RE: **Nuevo Atrisco**
Conceptual Grading and Drainage Plan
Plan Date: 3/30/18
Hydrology File: K10D058

Based on the information provided on 4/13/18 the above-referenced submittal cannot be approved for Site Plan for Building Permit until the following are addressed:

**CONCEPTUAL
GRADING AND
DRAINAGE PLAN
1 OF 2**

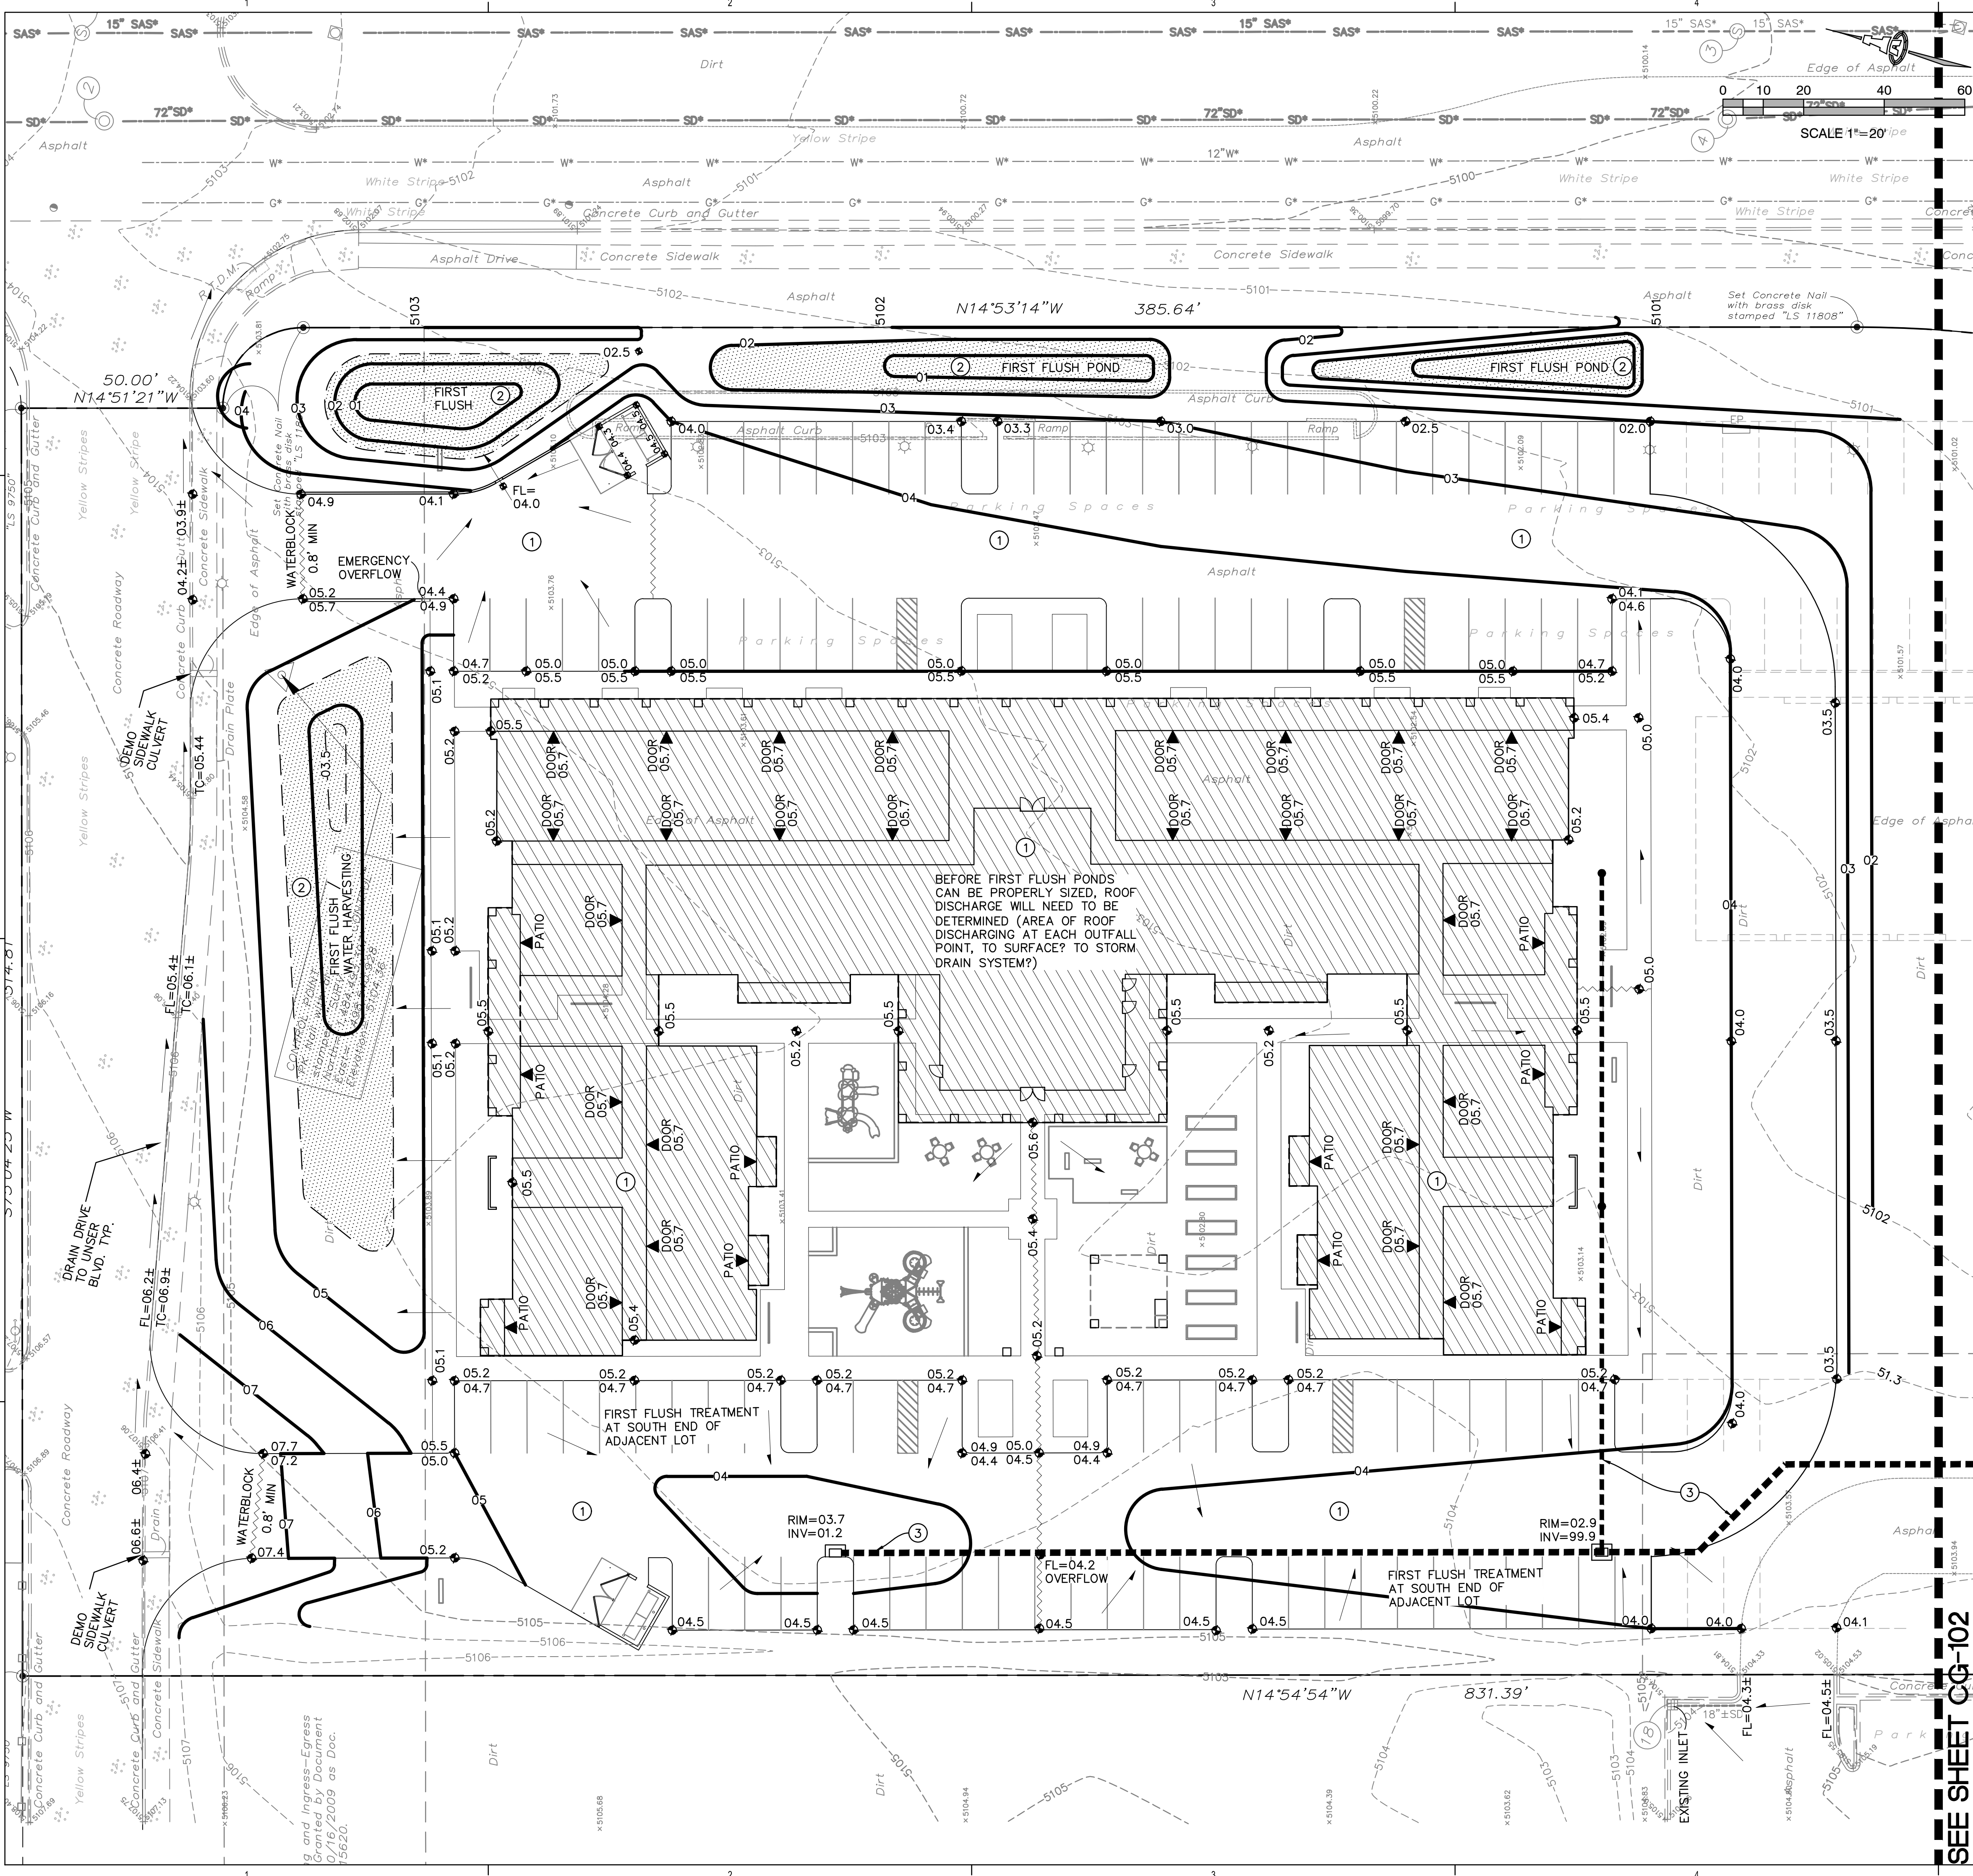
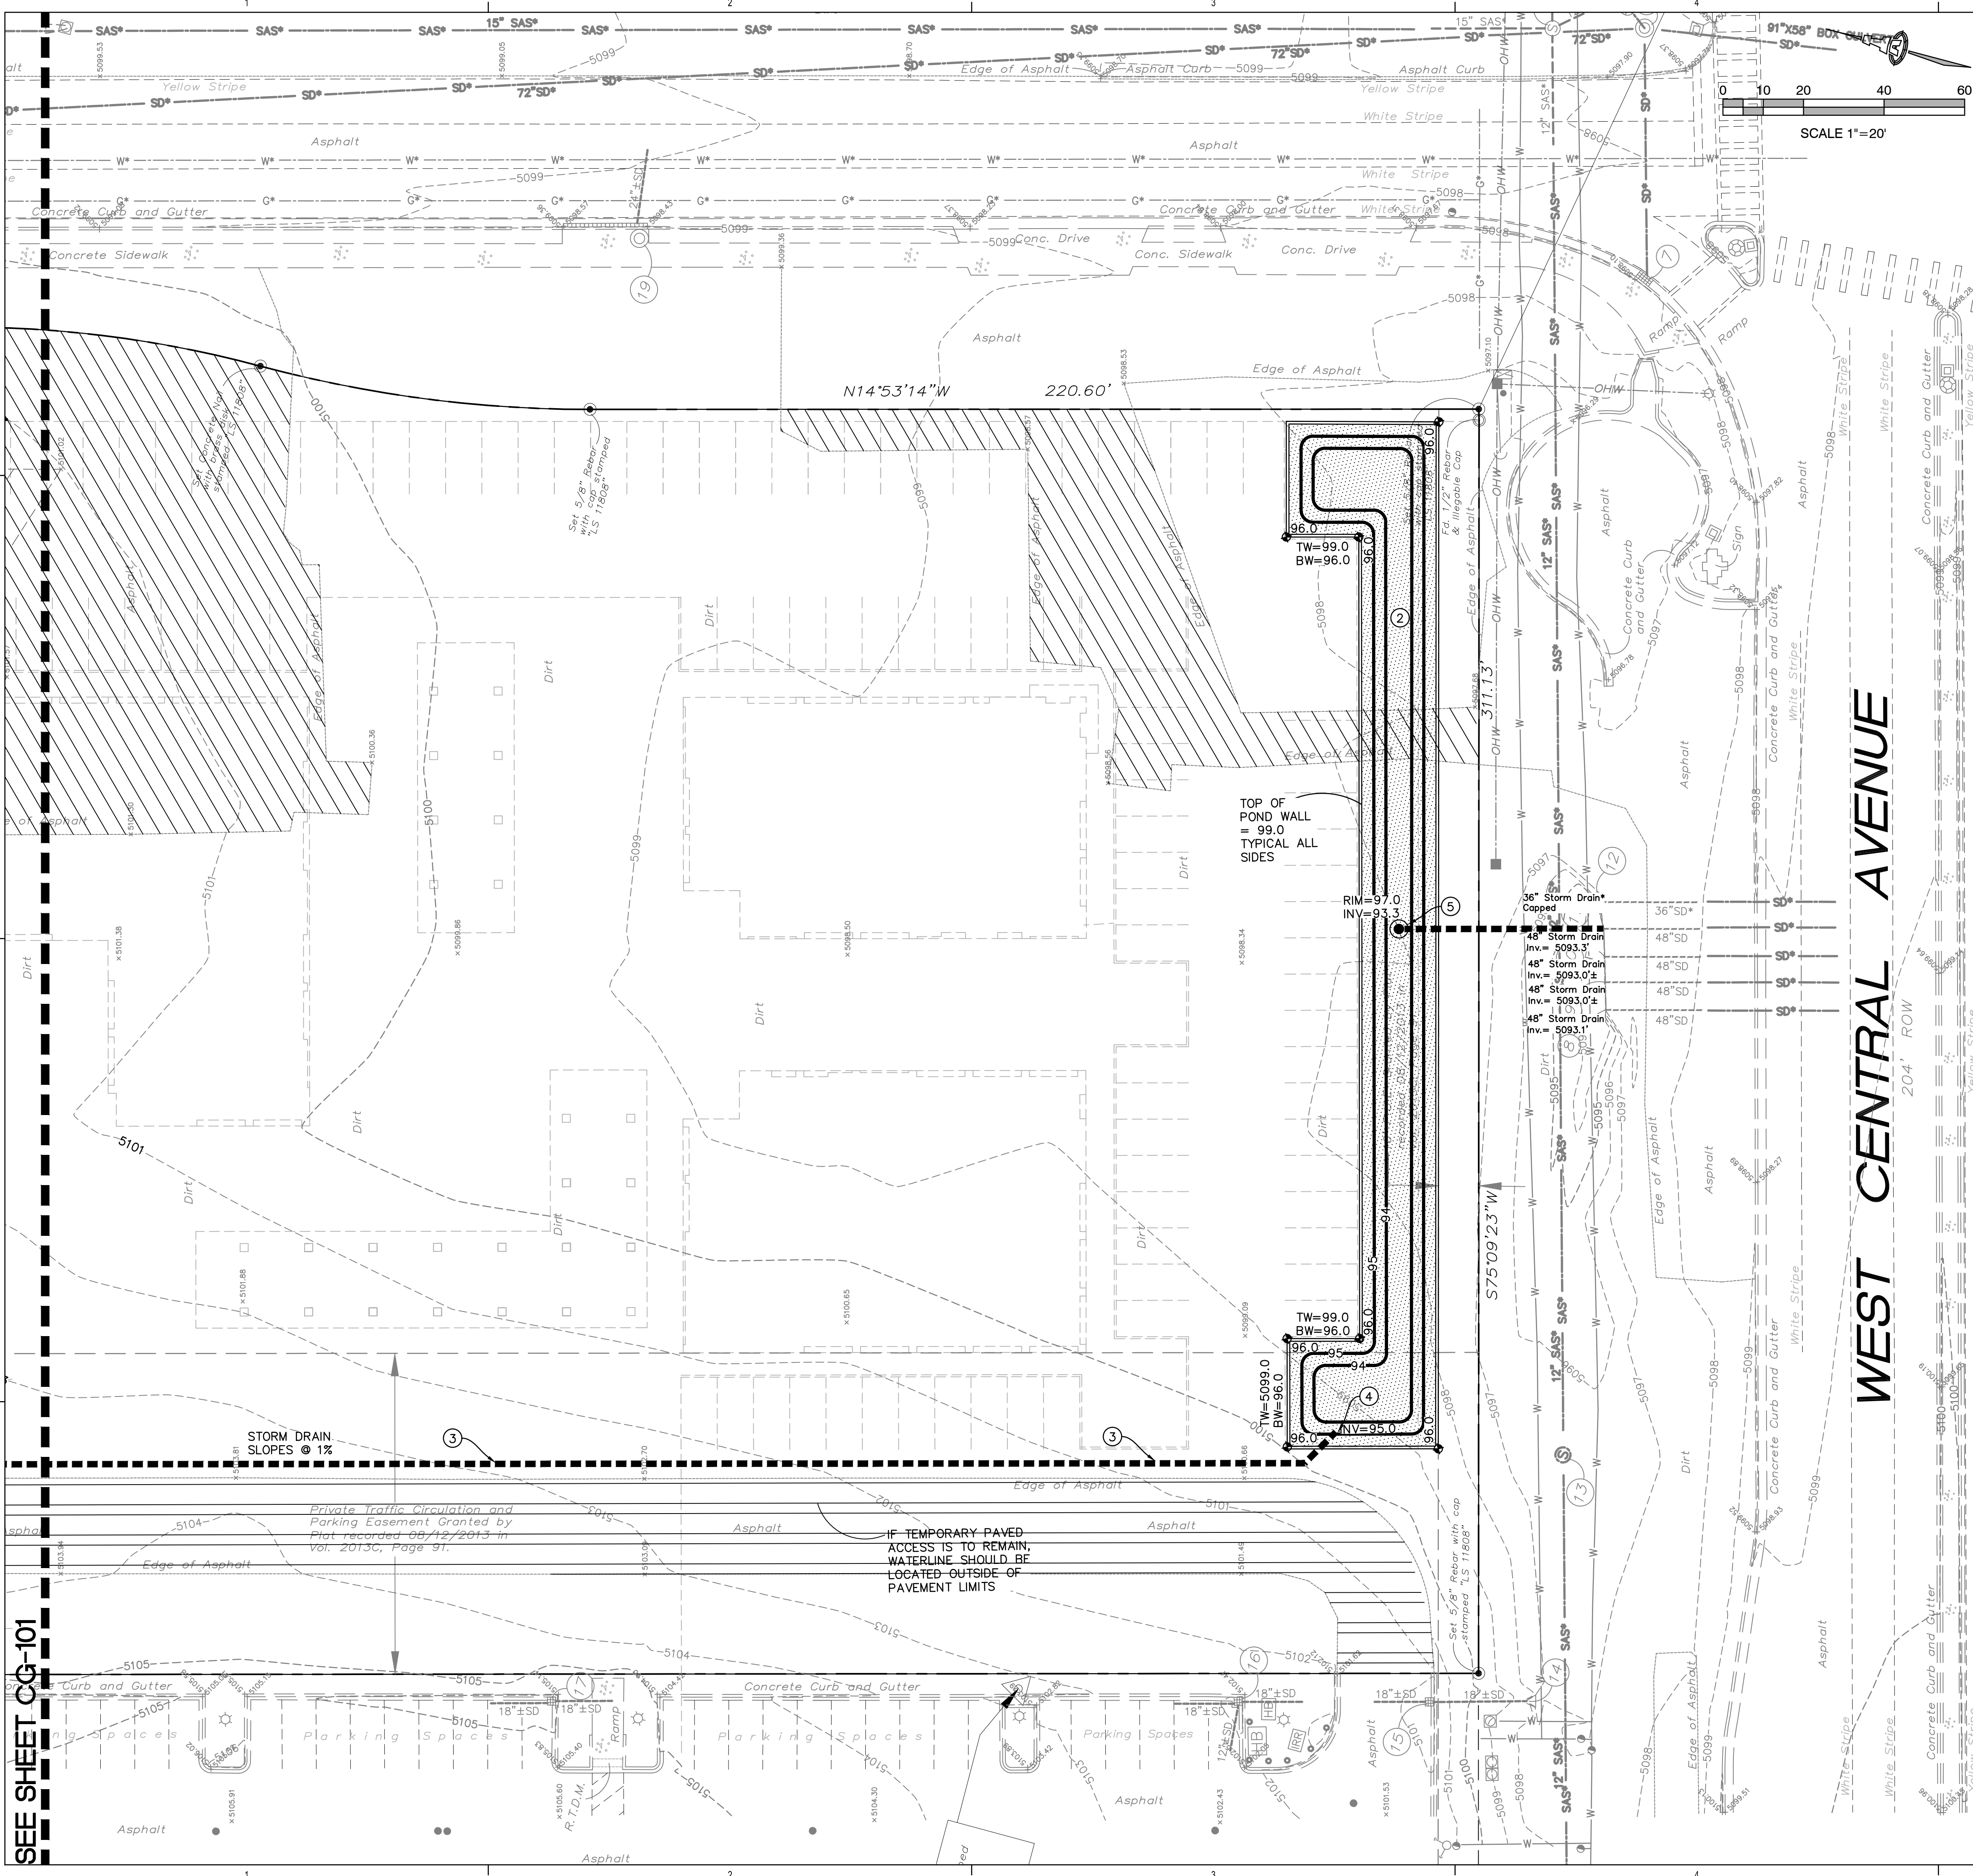
1. This site must demonstrate compliance with the allowable discharge rate of 3.4 cfs/ac, per the Huitt-Zollars 2017 report. Be sure to consider the internal roads that already free discharge and allow for future development of the southern portion of the lot, not built-out with this project.

2. Show the proposed property lines. It is likely that cross lot drainage easements and drainage covenants for the private storm drain and ponds will be required.

3. Demo of the existing parking area cannot be used to offset the first flush requirement. However, the demo and rebuild of this impervious area can be considered as redevelopment where the first flush requirement is only 0.26" x rebuilt impervious area. The remainder of the site being built over currently pervious surfaces will still be considered new development at a rate of 0.34" x new impervious area.

4. Subbasins need to be delineated and each pond sized for the area draining to it. Roof runoff needs to at least be estimated at this stage; if roof runoff changes it can be revised at the time of building permit.

5. This plan needs consider offsite flows along the northern access road and from the west and how they are conveyed through this site. Are there crosslot drainage easements in place? Does drainage from the west need to be conveyed to the new standpipe? An offsite drainage basin map would be helpful in assessing this.

6. Show the proposed grading and topo around the southern pond; it does not seem to tie-in to the existing contours. Also is any work proposed on the southern half of the lot? Will it be a staging area only?

7. Is this property site plan controlled? Or is the grading plan only prepared for the purpose of re-platting.
